SERVICE BULLETIN

Classification: EC17-028b	Reference: NTB17-104b	Date: February 26, 2018
------------------------------	--------------------------	----------------------------

2015 – 2017 SENTRA; ENGINE TURNS OFF OR HESITATES WHEN ACCELERATING FROM A STOP DURING HOT AMBIENT TEMPERATURES (100° F OR MORE)

This bulletin has been amended. Table A on page 4 has been revised, and additional information has been applied to step 7. No other changes have been made. Please discard previous versions of this bulletin.

Figure 3

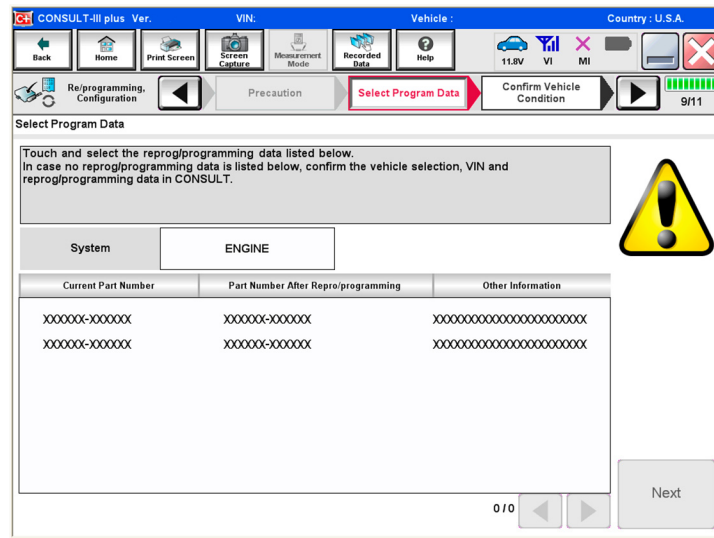
- In some cases, more than one new P/N for reprogramming is available.
 - In this case, the screen in Figure 3 displays.
 - Select and use the reprogramming option that **does not** have the message “Caution! Use ONLY with NTBXX-XXX”.
- If you get this screen and it is blank (no reprogramming listed), it means there is no reprogramming available for this vehicle.
